McPhillamys Gold Project (Mine Site and Water Supply Pipeline) - Exhibition

McPhillamys Gold Project – Environmental Impact Statement

McPhillamys Gold Project - Environmental Impact Statement

Example 1 – Inconsistencies between the assessors PCT mapping and native vegetation extent mapping - The blue shading is an area identified as PCT 731 by the assessor, the yellow hatching is the native vegetation extent identified by the assessor.

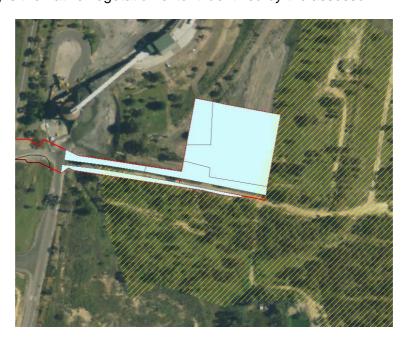
8. The native vegetation extent mapping is inconsistent with PCT mapping and aerial imagery

The native vegetation extent layer is inconsistent with the PCT vegetation mapping for the project. There are areas within the pipeline that have been mapped as a native PCT by the assessor however these areas have not been included in the native vegetation extent layer and calculation. Additionally, there are areas within the buffer area that appear to be native vegetation on the aerial imagery however they not been mapped on the native vegetation extent layer. Examples below.

Example 2 – Areas of vegetation within the linear buffer that have not been included in the native vegetation extent

Any vegetation that has been mapped as native vegetation by the assessor within the project area and the buffer should be included in the native vegetation extent mapping.

All native woody and non-woody vegetation on the subject land and within the buffer should be mapped.
